Planning reference 2017/6973/P | 29 New End, London NW3 1JD

I am writing in response to the draft basement impact assessment audit addendum recently completed by CampbellReith. In particular I refer to the point raised in paragraph 4.3, namely:

Figure 1 Borehole locations with cross sections A-A' (solid blue line), A-B' (dashed blue line) and C-C' (solid green line)

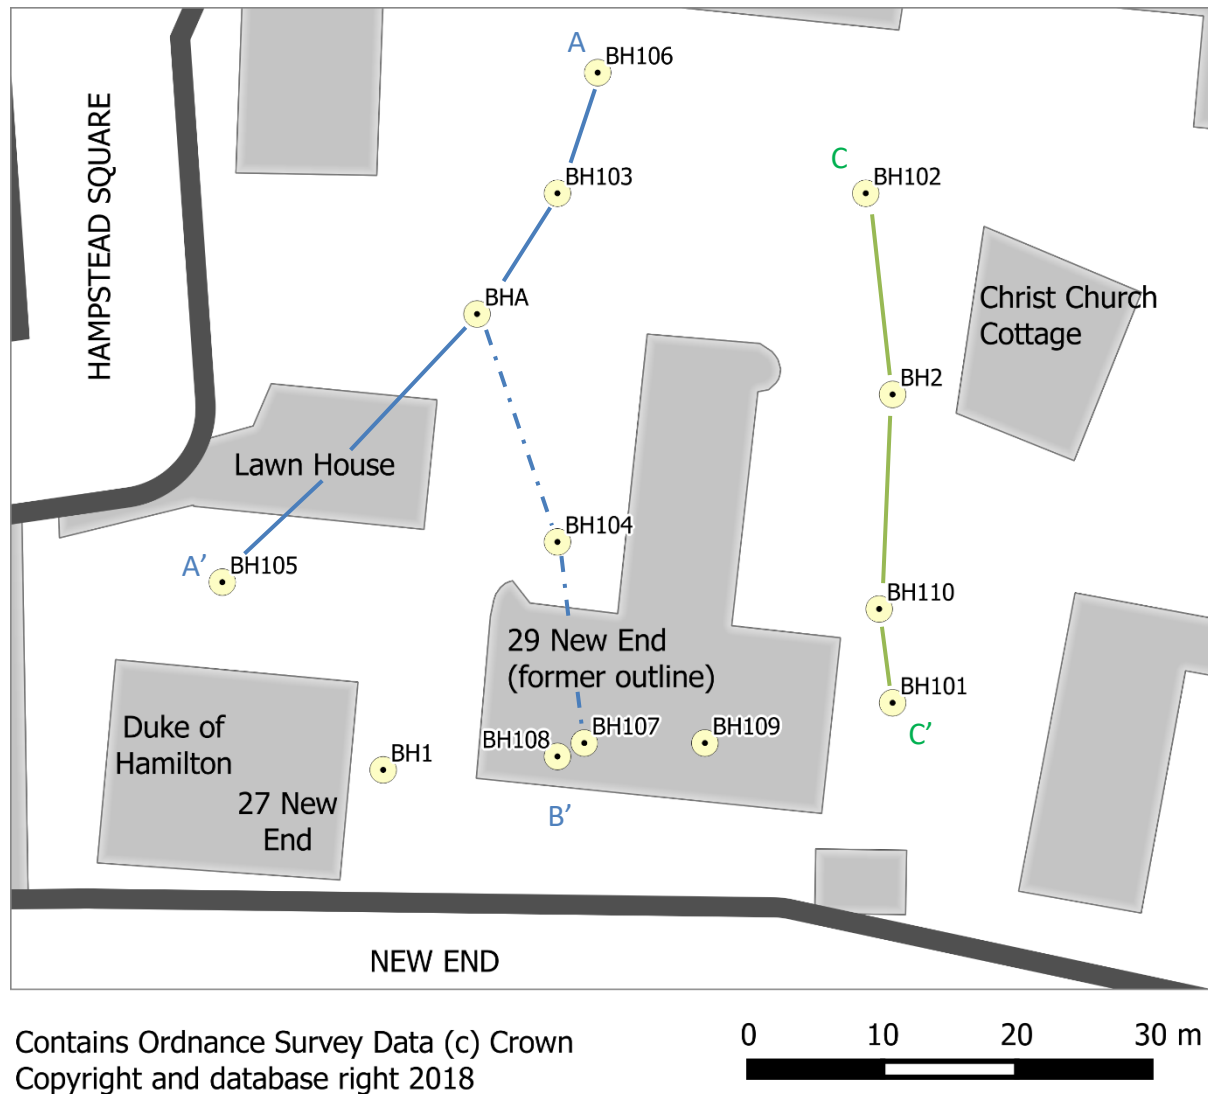
Locations of all the boreholes that have been referred to in the risk assessments (relative to the former building) are shown below. Due to site works since August 2016 many of the boreholes have been lost but BH102 and BH105 have been retained. BH106 to BH110 were drilled in December 2016 and January 2017.

Figure 2 Long-term borehole levels

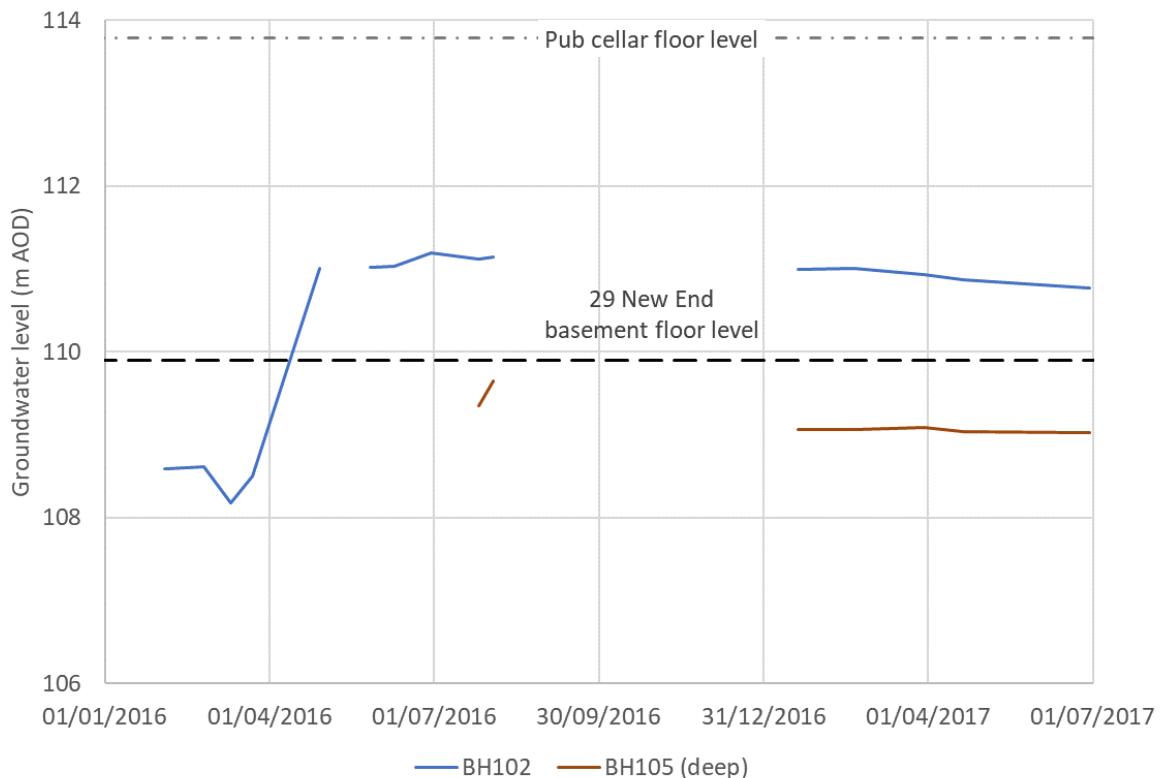
Water level measurements from all the boreholes are tabulated on the final page of this appendix. Time series for BH102 and BH105, the remaining boreholes used in previous interpretations, are plotted below. The levels are very similar from August 2016 to early 2017.

Of the newer boreholes, levels in BH106 (shallow), BH107 (shallow), BH108, BH109 and BH110 are all within the range of levels from previous monitoring. Levels in each borehole are consistent.

The level in BH106 (deep) is about 3 m deeper than the next deepest water level (BH101), possibly because BH106 is completed in a much deeper aquifer at around 90 m AOD, rather than BH101 which is completed at about 104 m AOD.

Water levels in BH107 (deep) have been irregular because it is completed in London Clay at depth (86 m AOD). The borehole was lost soon after due to site works.
